URGENT FIELD SAFETY NOTICE

M320 Microscope System

FSCA Identifier: CAPA-2017-04-001-H

Replacement of mechanical parts in M320 parallelogram / swing arm

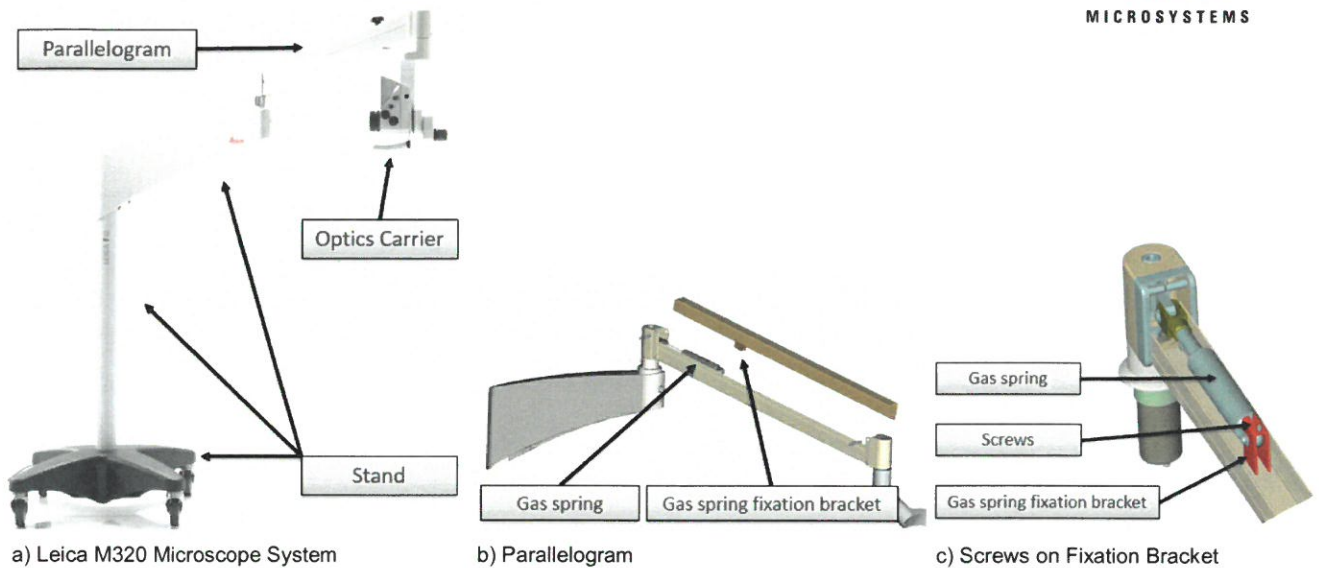
Recently three (3) complaints were reported involving mechanical part failures for the Leica M320 Microscope System. These specific systems had failures with the screws that hold the gas spring fixation bracket in place (see picture c below). Due to this failure, the gas spring, which is fixed to the upper part of the parallelogram, cannot hold up the weight of the optics carrier. This may potentially cause the M320 optics carrier to drop to the lower mechanical end stop (see pictures a and b below).

This failure was identical in all three (3) complaints and has been linked to an identified batch of screws, used in the manufacture of the gas spring fixation bracket. These screws have been determined to be non-conforming.

This defect does carry some potential injury risk. In the unlikely event that this observed defect were to occur, the M320 optics carrier may unintentionally drop into the surgical field, risking contact with the patient.

Leica Microsystems has chosen to initiate a field update to replace mechanical parts of the parallelogram for all M320 microscopes manufactured with screws from the nonconforming batch to ensure customer satisfaction and patient safety.
